PROPOSED ALTERATIONS 40 MONASH PARADE, DEE WHY FOR CARYN CAVANAGH LOT 53A DP101690			
WEST, EAST & NORTH ELEVATION			DRG. NO. 08-16-MON
DATE AUGUST 2016	DRAWN J.WRIGHT	SCALE 1:100	SHEET NO. 3A

PROPOSED ALTERATIONS

40 MONASH PARADE, DEE WHY

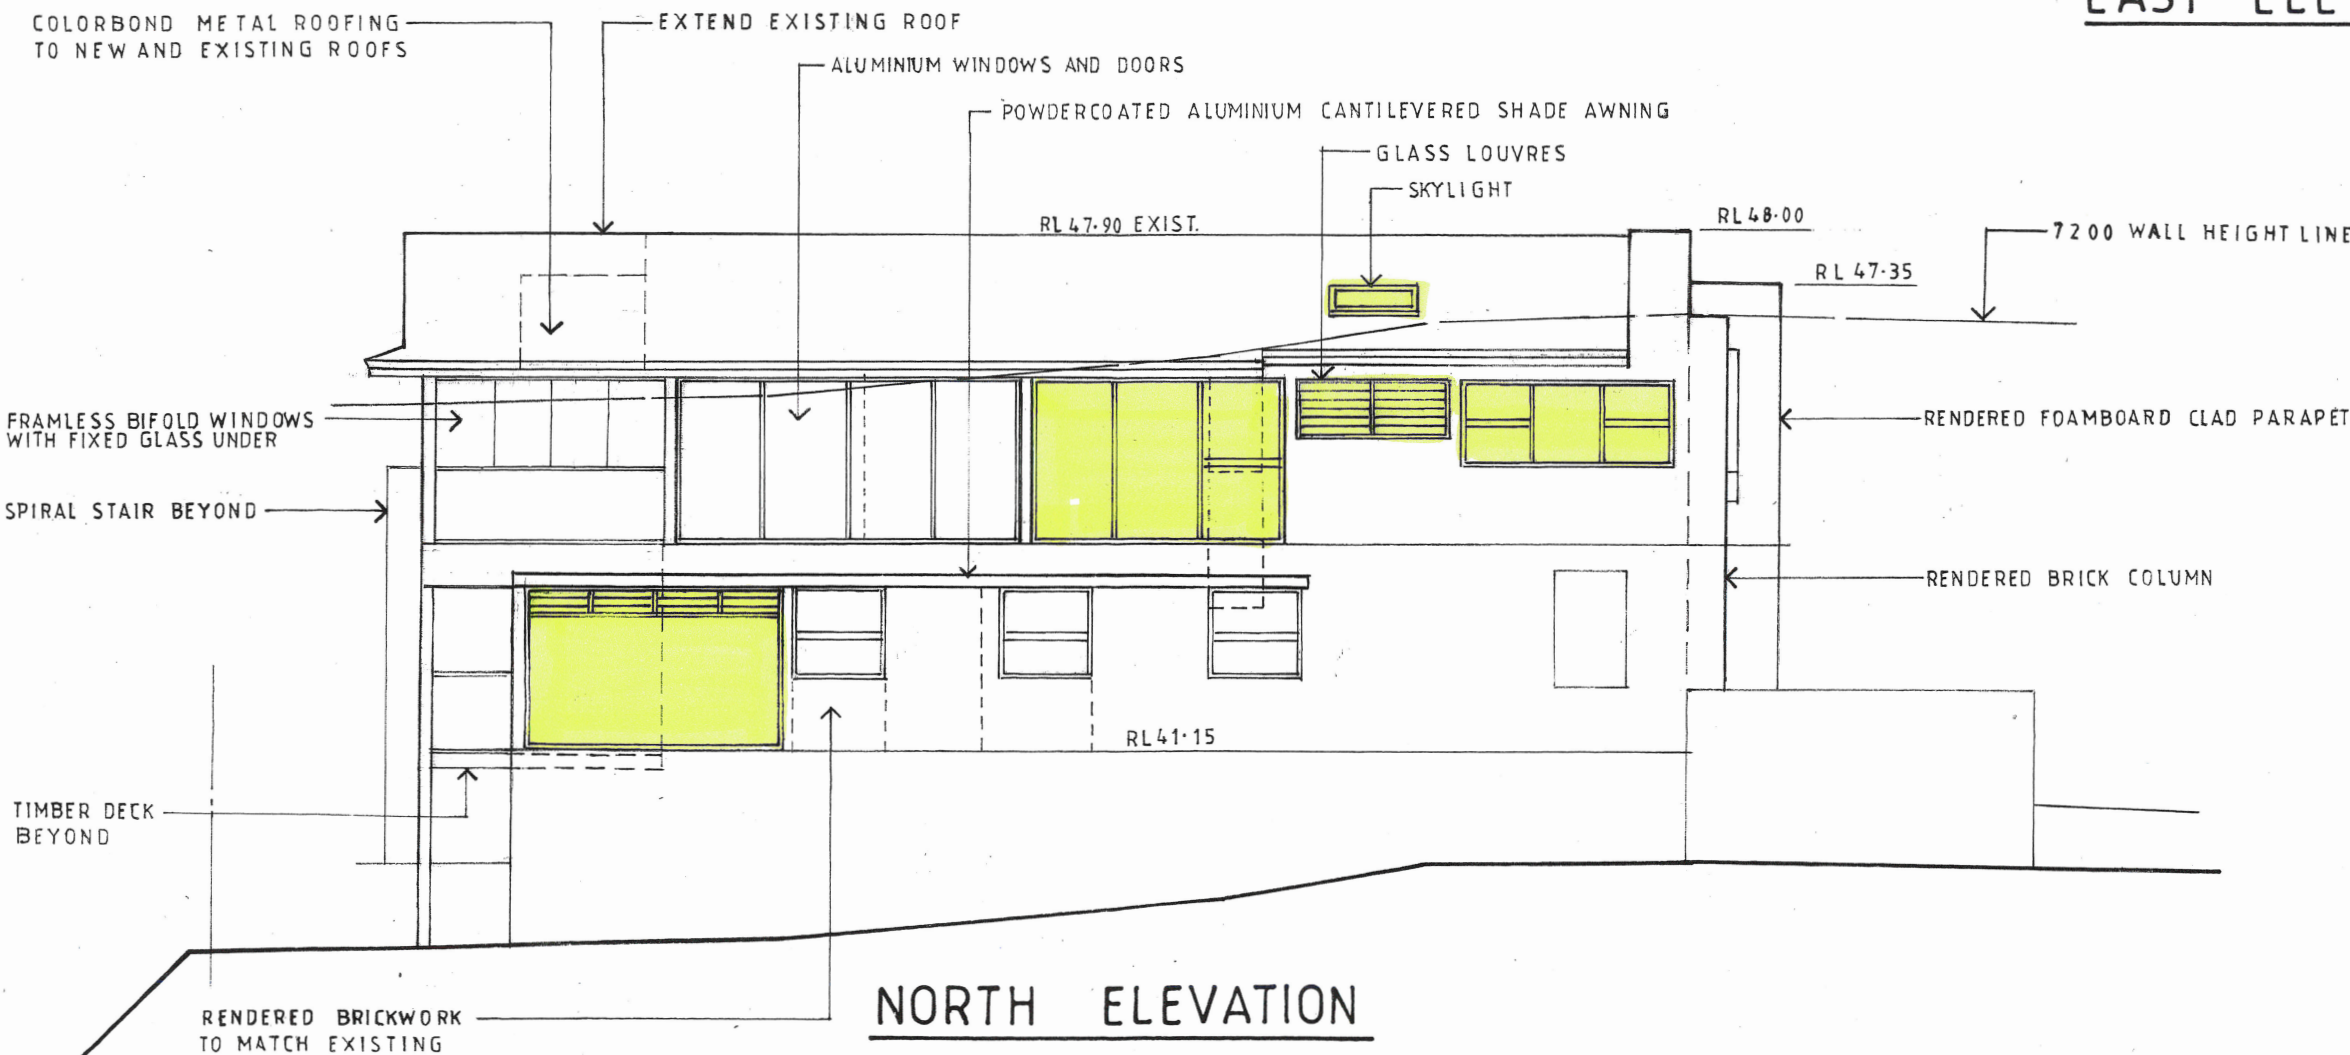
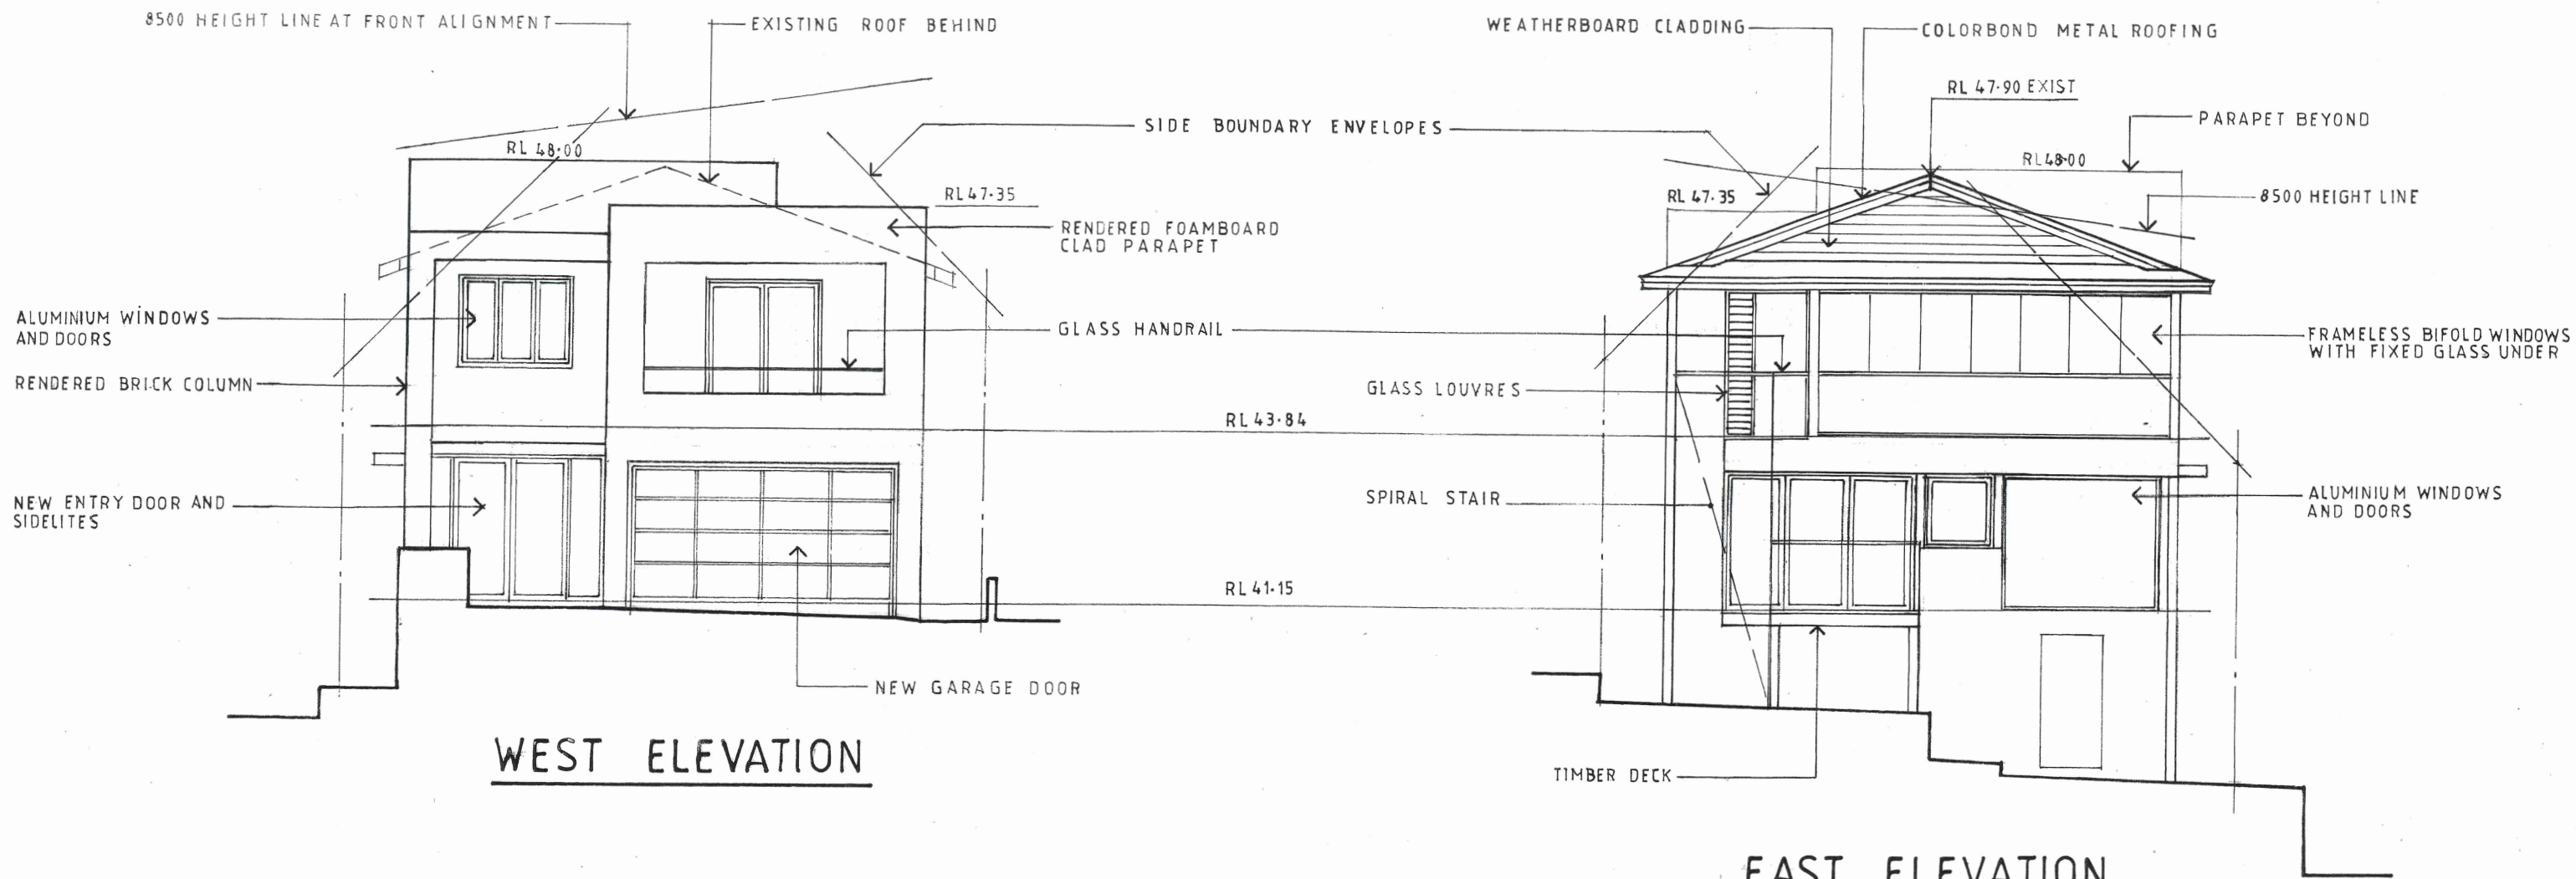
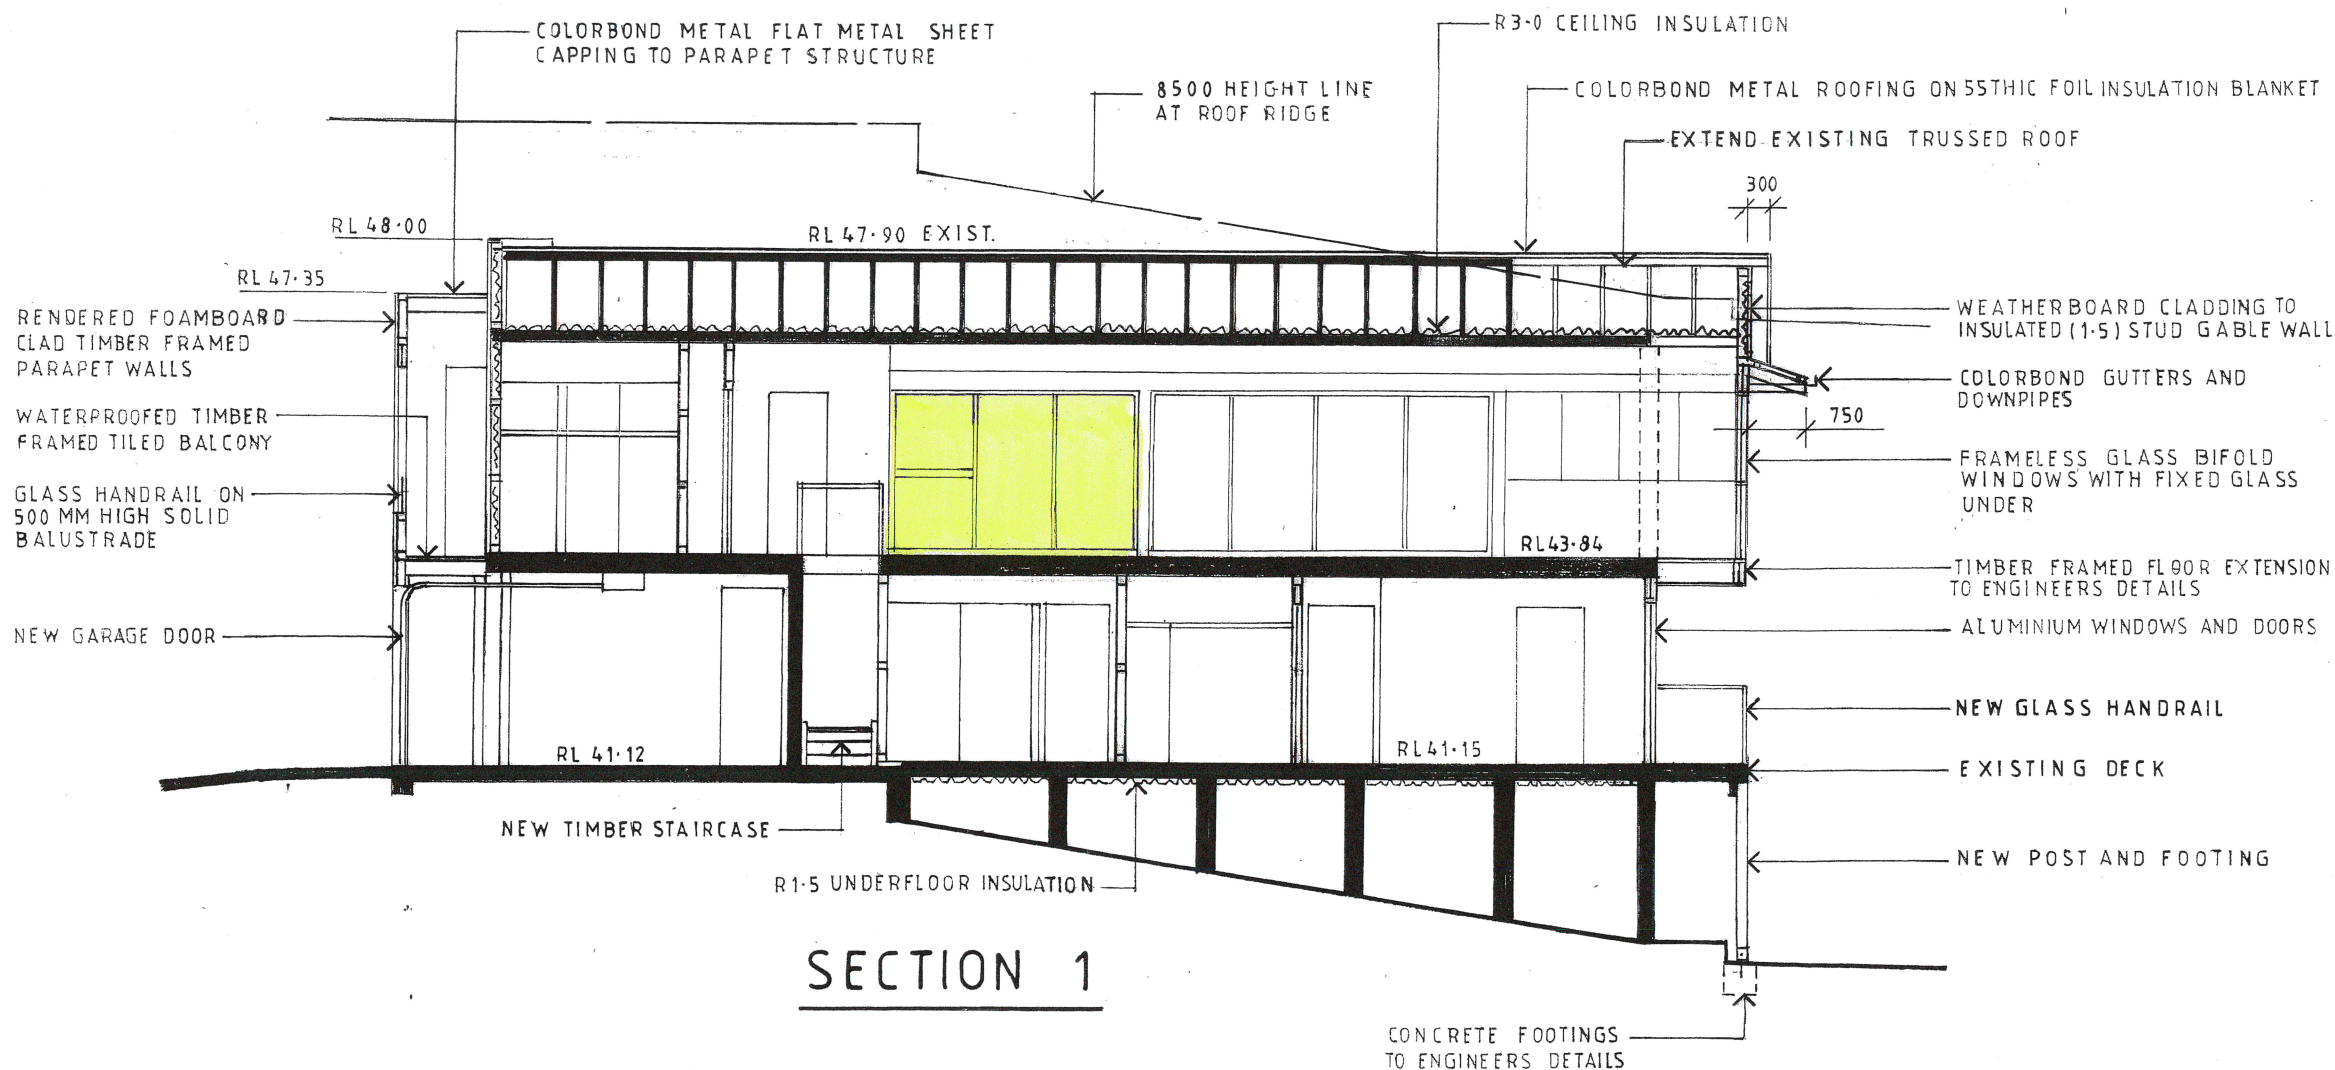
DATE	REVISION
A 12-11-18	WINDOWS TO NORTH ELEVATION REVISED AND SKYLIGHT ADDED.

SOUTH ELEVATION & SECTION

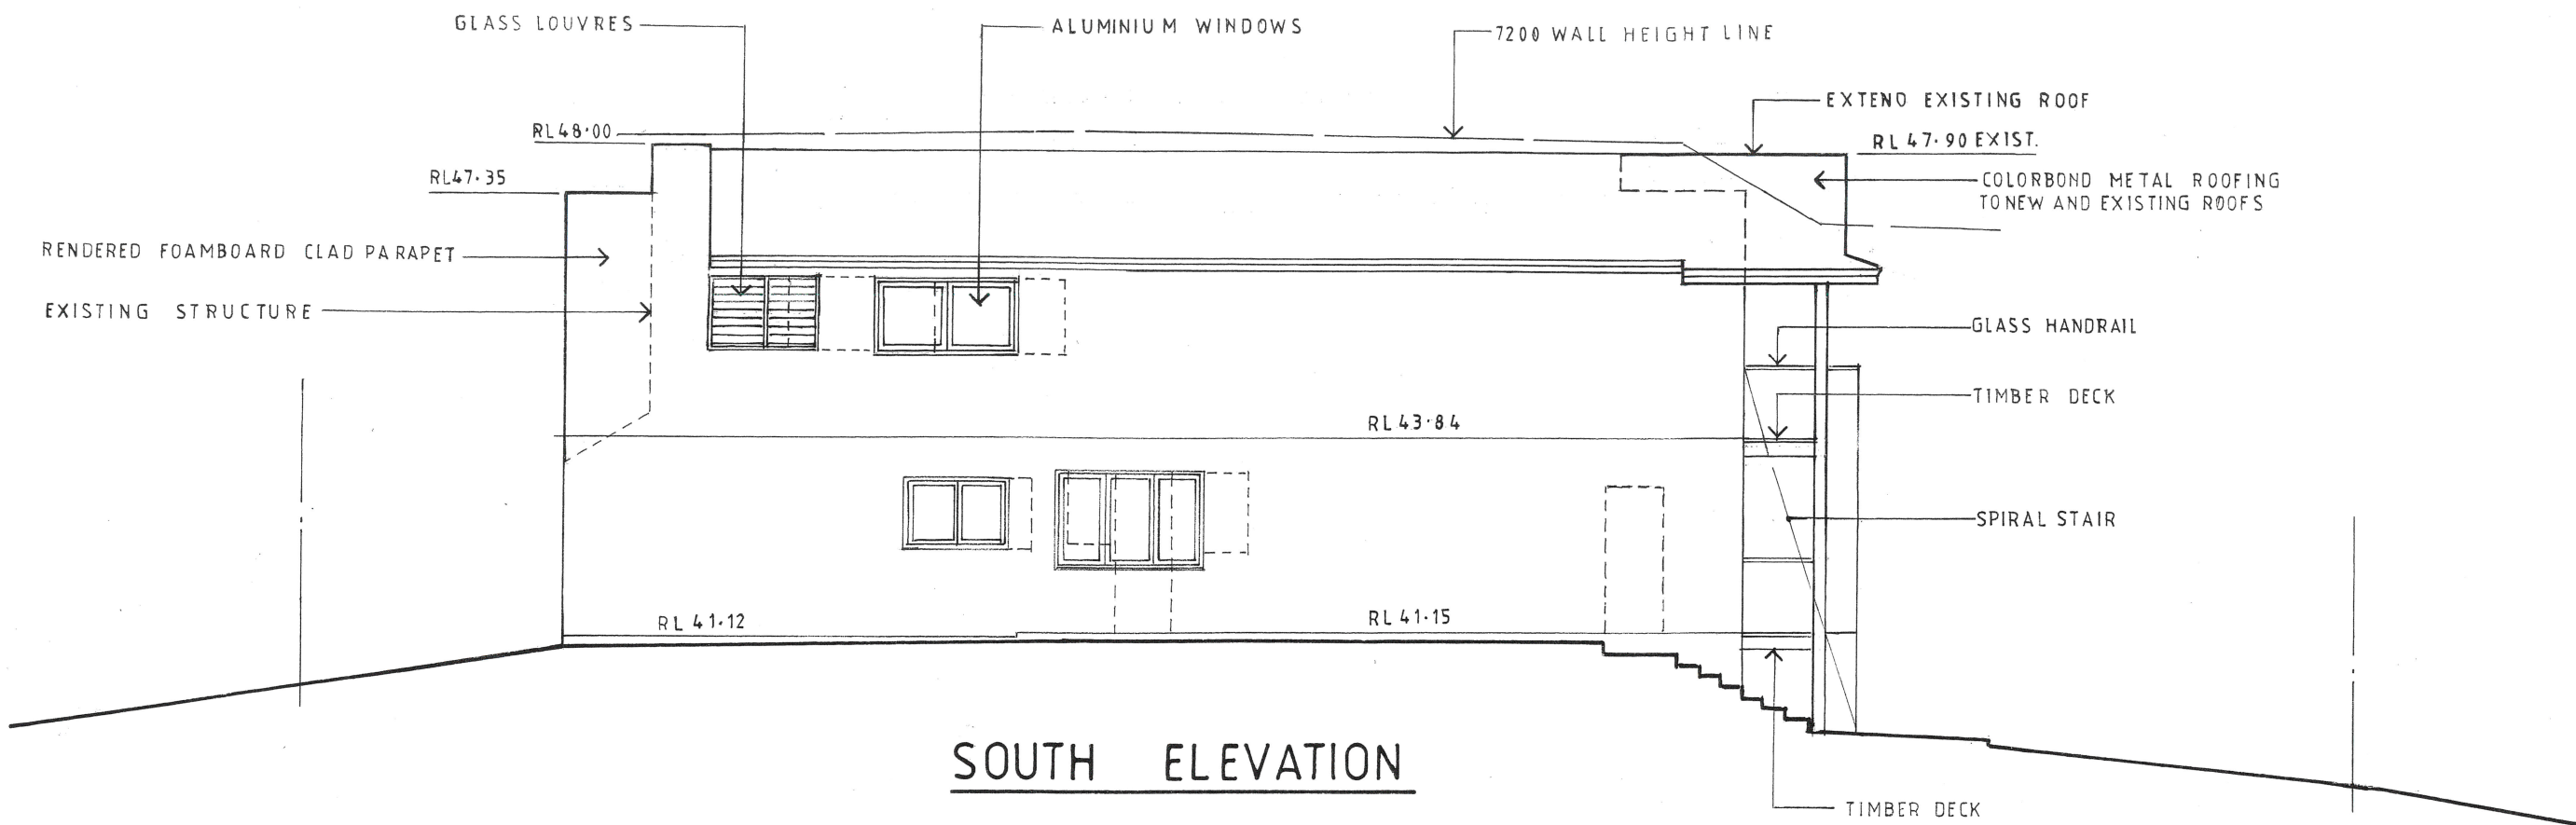
DATE	REVISION
A 12-11-18	FIRST FLOOR NORTHERN WINDOWS REVISED
